TO: WALKABLE NOVI COMMITTEE
FROM: MARK SPENCER, AICP, PLANNER *MSB*
THROUGH: BARBARA MCBETH, AICP, DEPUTY DIRECTOR
OF COMMUNITY DEVELOPMENT
SUBJECT: CIDER MILL/EMERALD FOREST BIKE ROUTE ISSUES
DATE: SEPTEMBER 14, 2012

TO: WALKABLE NOVI COMMITTEE
FROM: MARK SPENCER, *A/CP*, PLANNER
SUBJECT: EMERALD FOREST CIDER MILL NEIGHBORHOOD
CONNECTOR ROUTE
DATE: NOVEMBER 14, 2012

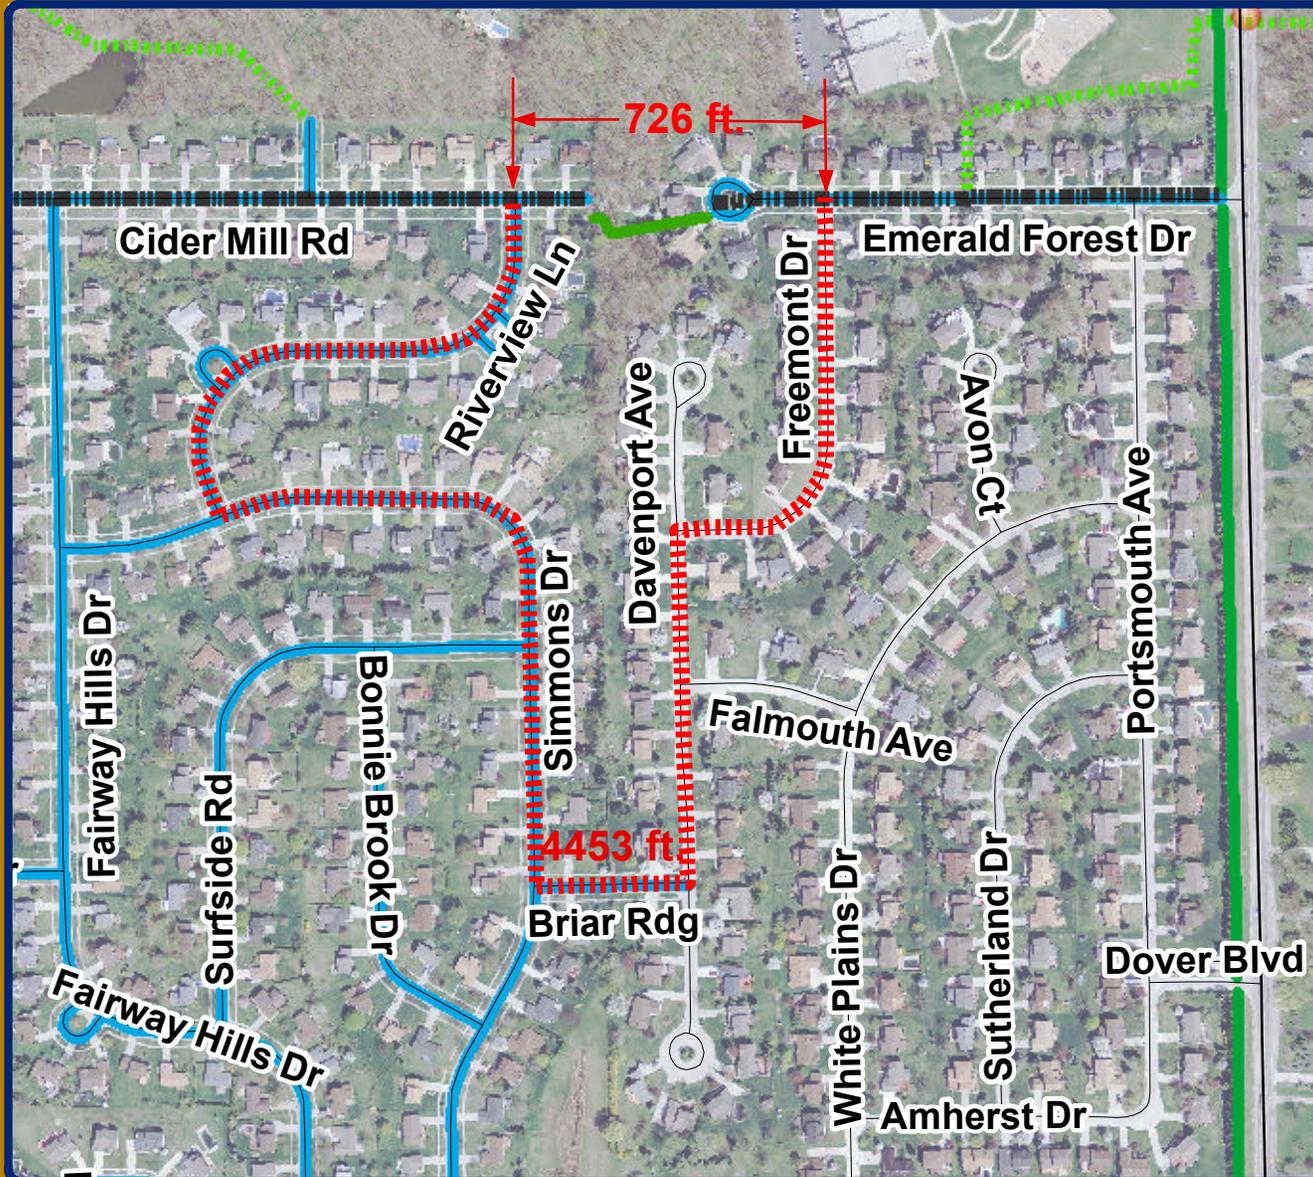
- The City could mark the route as a “Neighborhood Connector Route” using a modified route identification sign as contemplated in the NoMo Plan instead of using “Bike Route” signs. The use of a neighborhood connector route sign would not reduce the number or the size of any proposed signage. If additional signage was proposed in the walkway easement, a smaller “route” sign be used. The conceptual sign at the right would need to be reviewed by other staff members and maybe City Council.

Cider Mill/Emerald Forest Route with Alternate 1

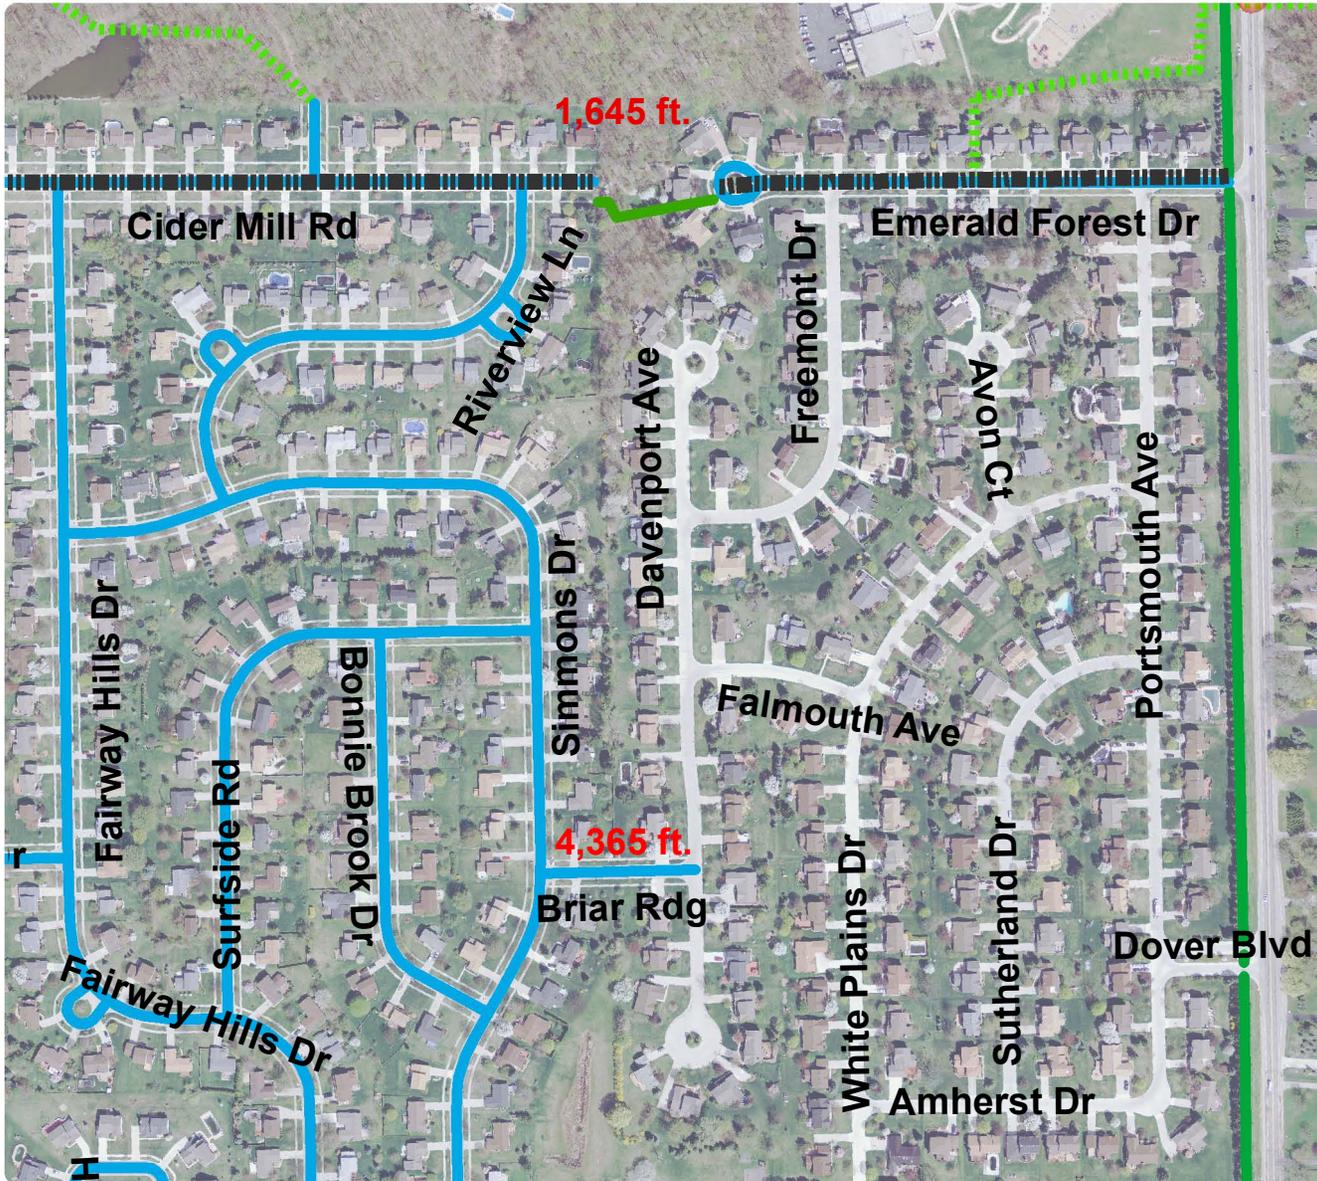
- Staff could review reducing in the number of proposed signs at Ten Mile and Taft Roads without compromising the purpose of the signage.
- Directing route users to use Alternate Route No. 1 (Riverview Lane, Simmons Drive, Briar Ridge, Davenport Avenue, Freemont Drive see attached map) would add 3,700 feet (0.7 miles) or 70% to the route between Beck and Taft Roads. This route would require the addition of 9 sign faces (some signs face opposite directions and could share the same post).

Alternate Route 2
2,720 feet longer

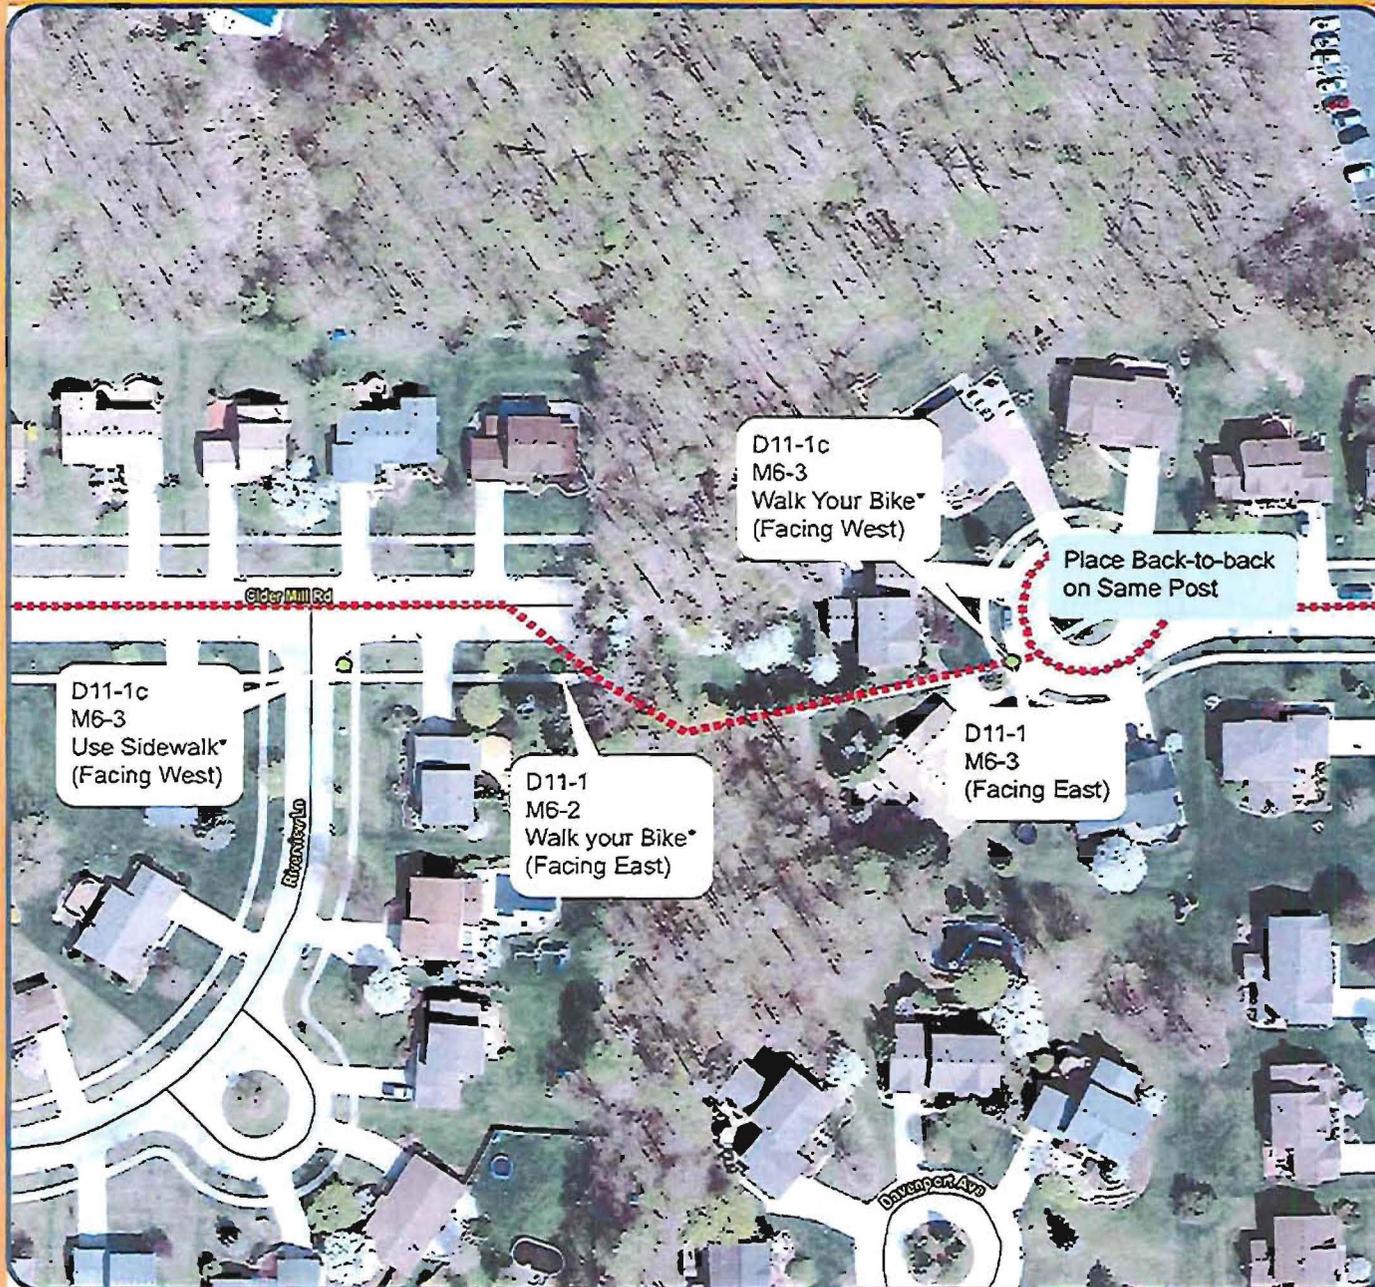
- Directing route users to use Alternate Route No. 2 (Fairway Hills Drive, Simmons Drive, Briar Ridge, Davenport Avenue, Freemont Drive see attached map) would add 2,700 feet (0.5 miles) of 50% to the route between Beck and Taft Roads. This route would require the addition of 9 sign faces (some signs face opposite directions and could share the same post).
